SECY-79-606

Subject: ISSUANCE OF STAFF CRITERIA FOR THE MARK I CONTAINMENT
LONG TERM PROGRAM

NRC ACCEPTANCE CRITERIA
FOR THE
MARK I CONTAINMENT
LONG TERM PROGRAM

Figure 2.10-2 Impact and Steady Drag Force Correlation for Type 1 Deflector

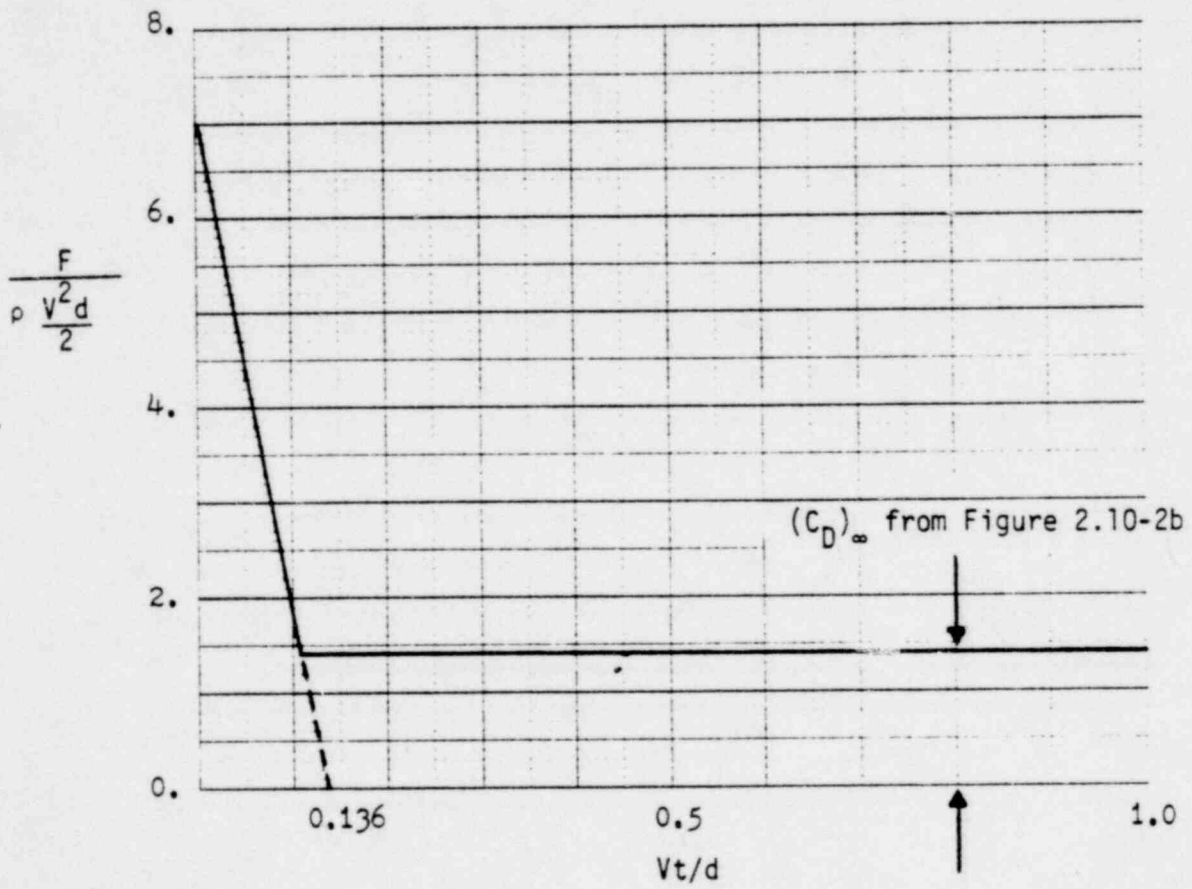
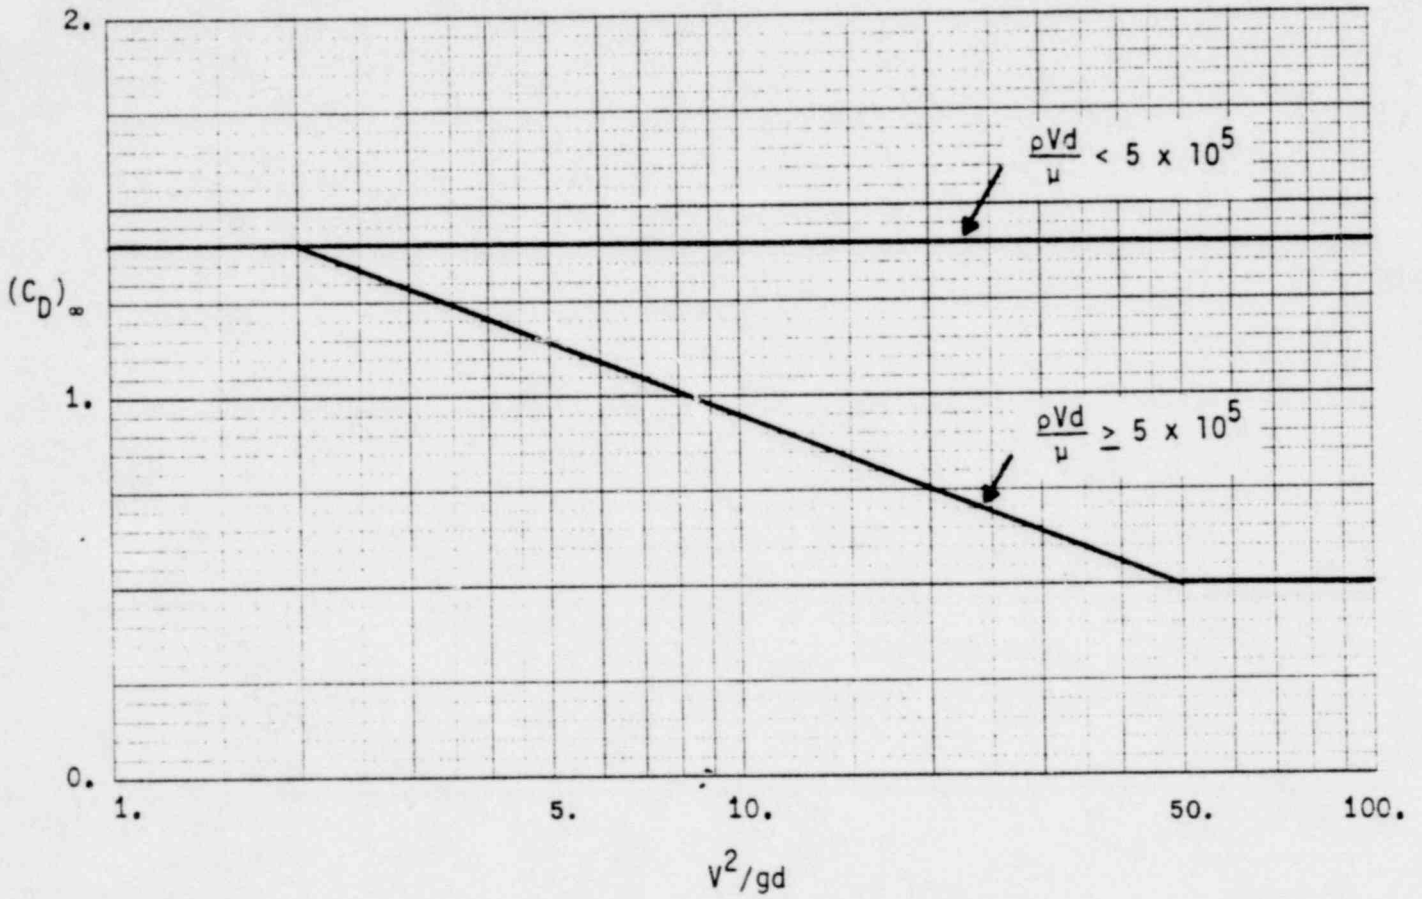
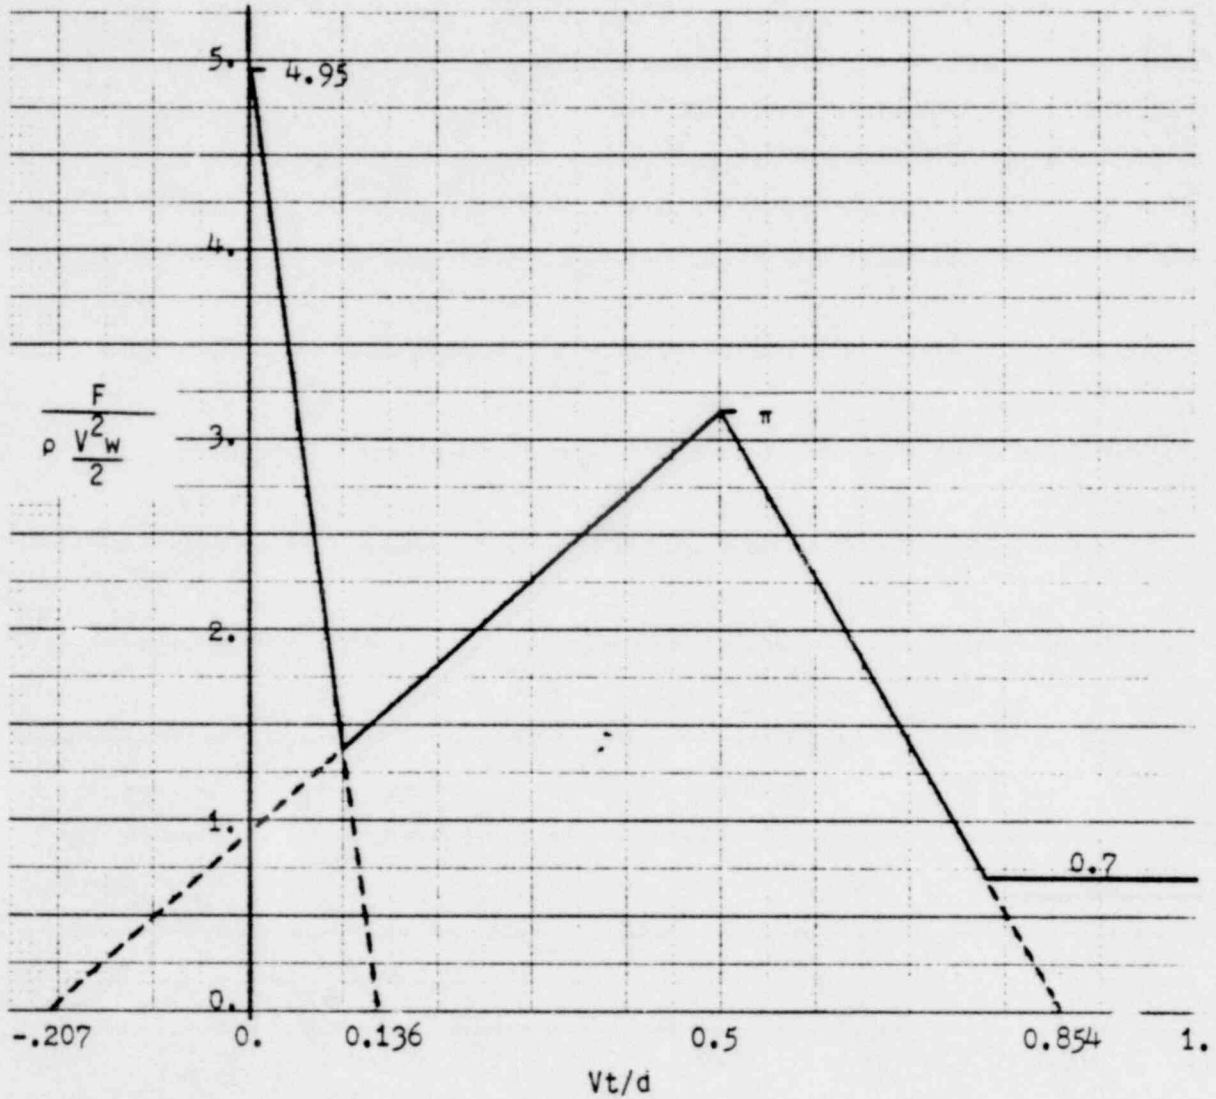
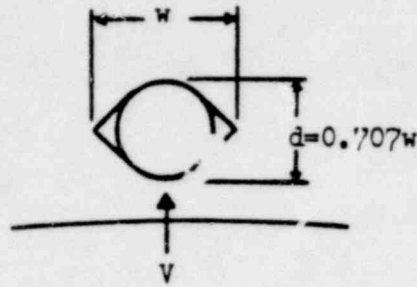
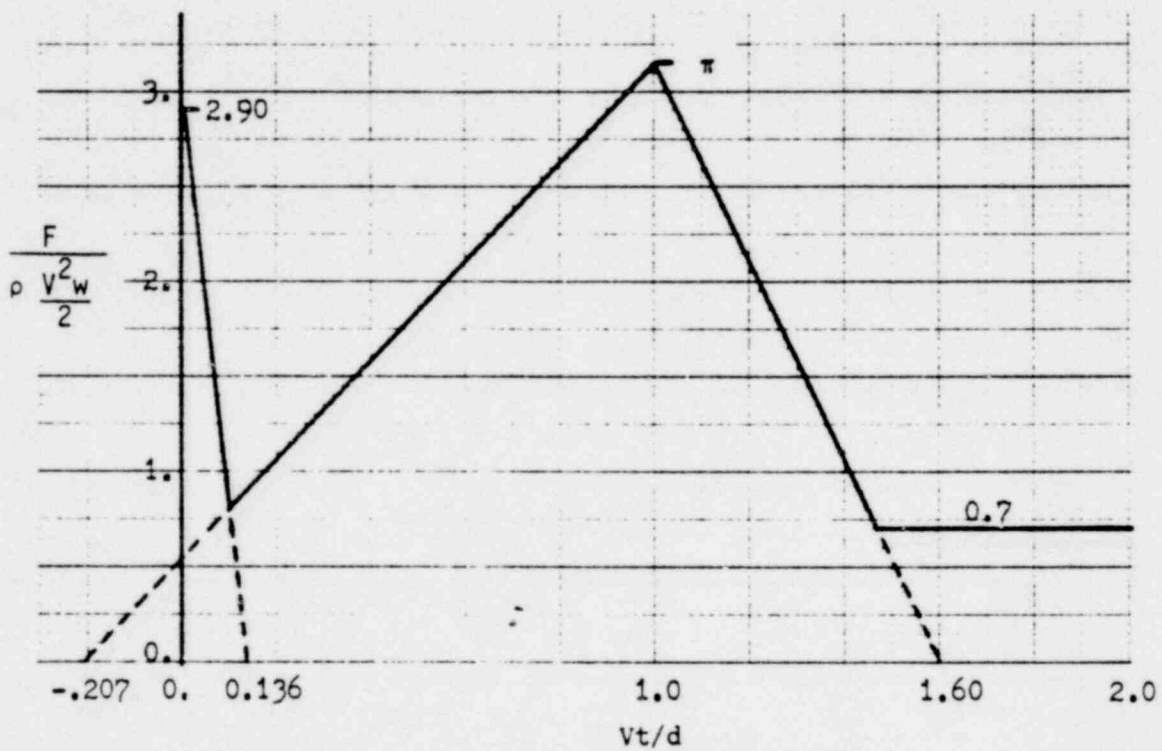
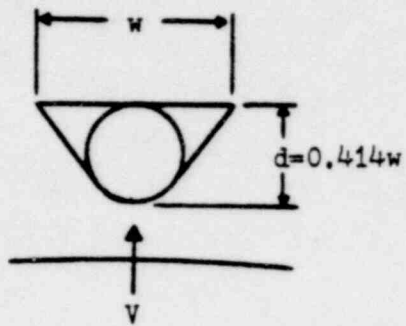
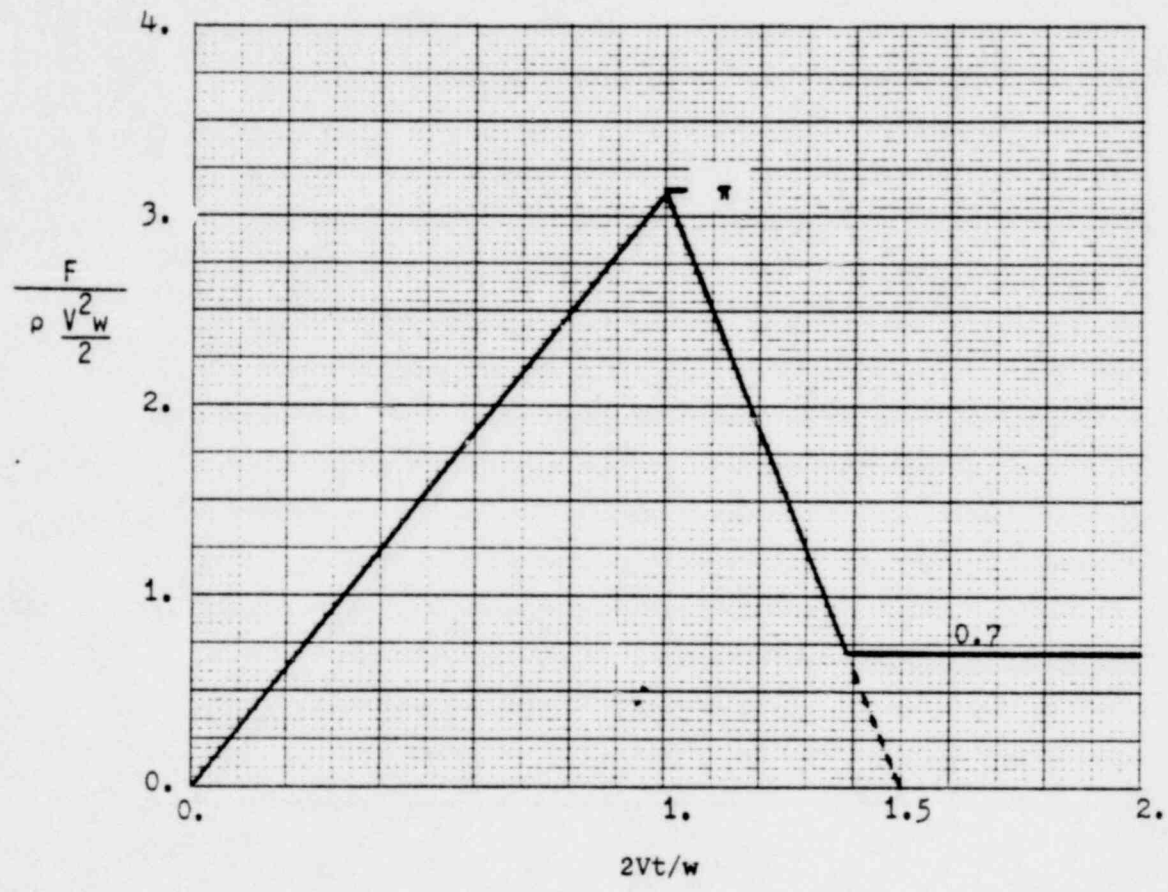
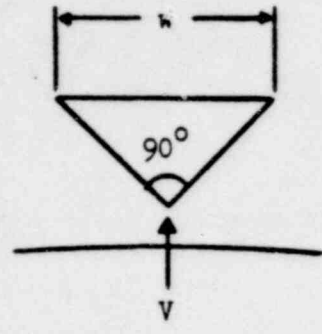
1. The impact transient and "steady drag" contributions to the load shall be computed from the correlations shown on Figures 2.10-2 through 2.10-5, for deflector types 1 - 4, respectively. For times past the periods shown, the last value shall be extended for the duration of the transient.
2. The three-dimensional load variation and timing shall be based on the EPRI "main vent orifice" tests, as discussed in Section 2.5.
3. The gravitational component of the acceleration drag shall be included in F_A , as defined in NEDO-24612.
4. In computing the deflector response to the load, the added mass of the water shall be accounted for, as described in Section 2.10.1.3 above.
